1
 A4 1/2"=1'-0"
TYPICAL CROSS SECTION AT GARAGE AND NEW DINING ROOM

Re: Residential Renovation
 78 Hersey Street
 Portland, Maine

Project Number: 16-076

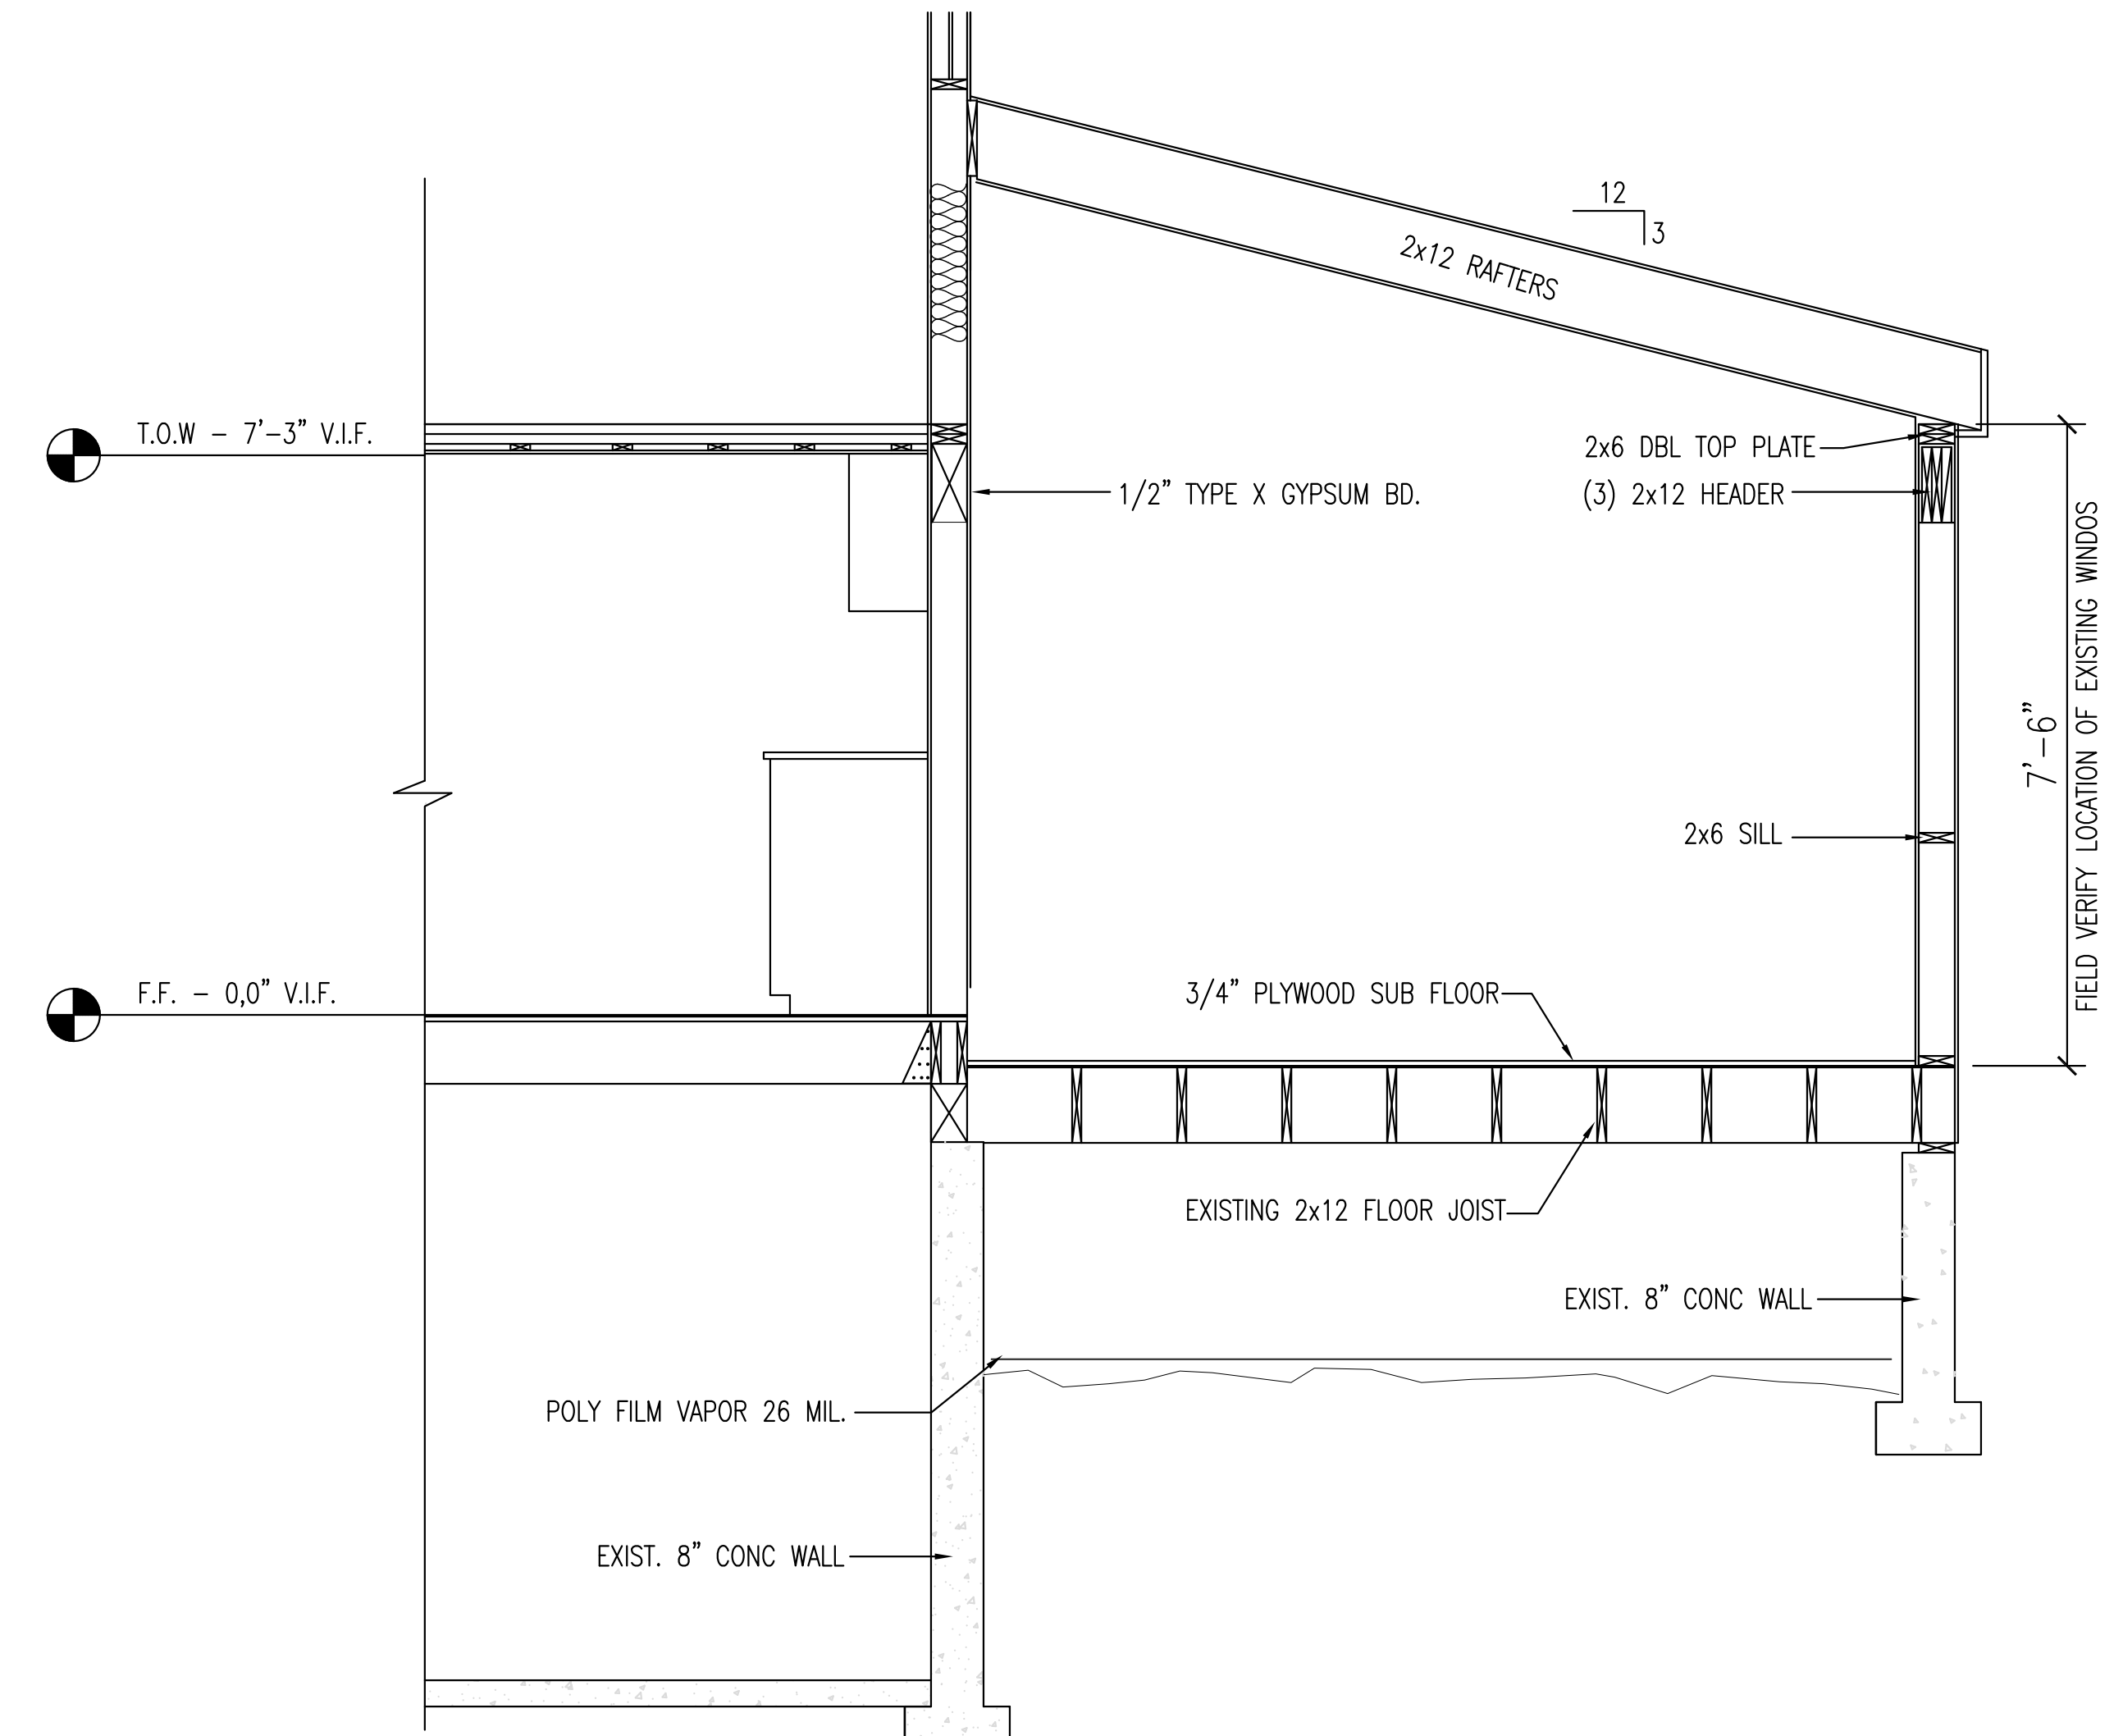
1. PROVIDE NEW SIMPSON FACE MOUNT HANGERS TO SUPPORT EXISTING FLOOR JOIST OFF OF EXIST 2x LEDGER. FASTEN LEDGER W/ (2) 5/16"x4" GRKs
2. GENERAL CONTRACTOR TO VERIFY ALL DIMENSIONS PRIOR TO CONSTRUCTION.
